From: [REDACTED]
Sent: 5/06/2024 10:46:33 PM
To: Council Northernbeaches Mailbox
Cc: Titus; Anthony Ng
Subject: TRIMMED: DA 2022 1848; 173A SEAFORTH CRESCENT SEAFORTH
NSW 2092 WRITTEN SUBMISSION: LETTER OF OBJECTION
SUBMISSION: TULLOCH
Attachments: 173A WS 5 JUNE 24.pdf;

SUBMISSION

RE: DA 2022 1848;
173A SEAFORTH CRESCENT SEAFORTH NSW 2092
WRITTEN SUBMISSION: LETTER OF OBJECTION
SUBMISSION: TULLOCH

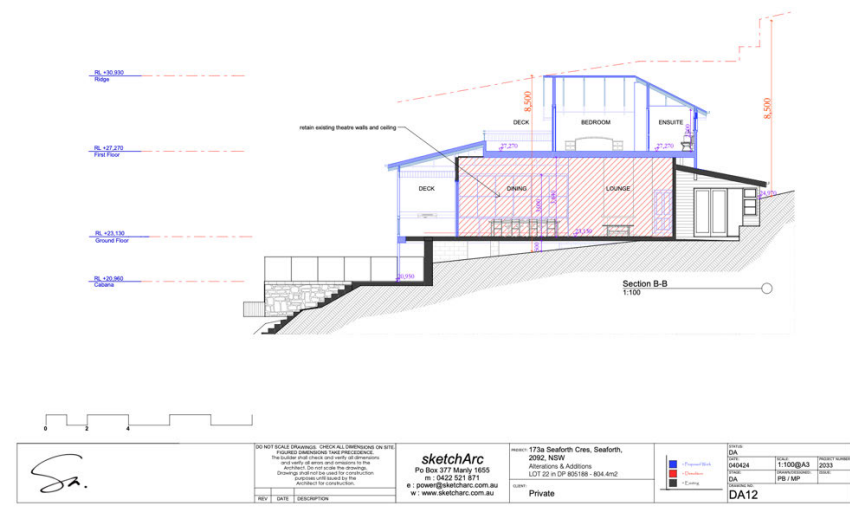
Council will note the existing ground levels under the dwelling as depicted within photography of the HIS.

I ask Council for the '*ground level existing*' levels throughout this zone to be accurately measured by the Applicant's Registered Surveyor, so an accurate HOB can be assessed.

Council can easily assess that the sub floor shown on DA 12, has no similarity to the subfloor shown on the HIS photographs. The Section on DA 12 suggests a 0.5m distance from FFL to the EGL – the photography suggests that this height would be 2.0m+. No survey has been provided to areas that are clearly accessible. HOB would clearly be >10m.
